REMARKS

The present Amendment is in response to the Office Action dated March 19, 2003 in reference to the above-identified application. The Examiner set a shortened statutory period for reply of three (3) months, making the present Amendment due by June 19, 2003. Filed concurrently herewith is a request for a three-month extension of time so that the present Amendment is due by September 19, 2003.

Fig.1

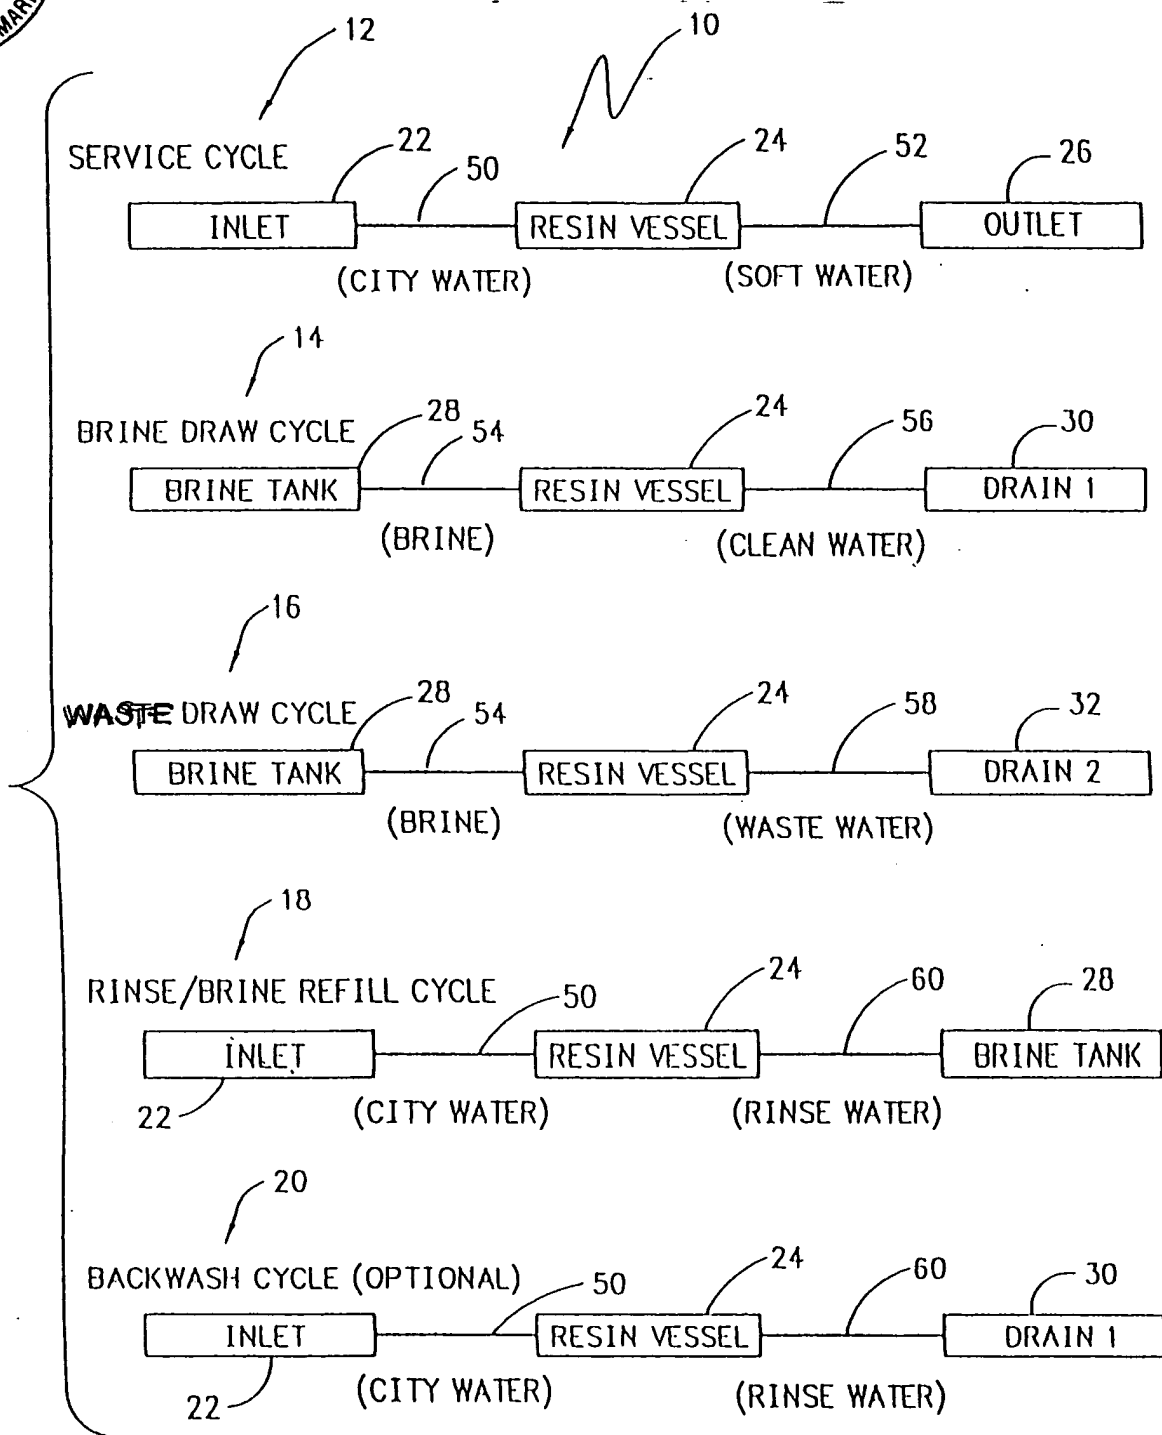
At the outset, the Examiner has objected to Figure 1 of the drawings because element 16 is incorrectly labeled as the "BRINE DRAW CYCLE". Appropriate correction has been made to Figure 1 so that element 16 is labeled as "WASTE DRAW CYCLE". Accordingly, submitted herewith is an "Annotated Sheet Showing Changes", wherein the word "WASTE" is written in red to indicate that element 16 has been amended. In addition, Applicant has submitted herewith a "Replacement Sheet" without markings, of amended Figure 1.
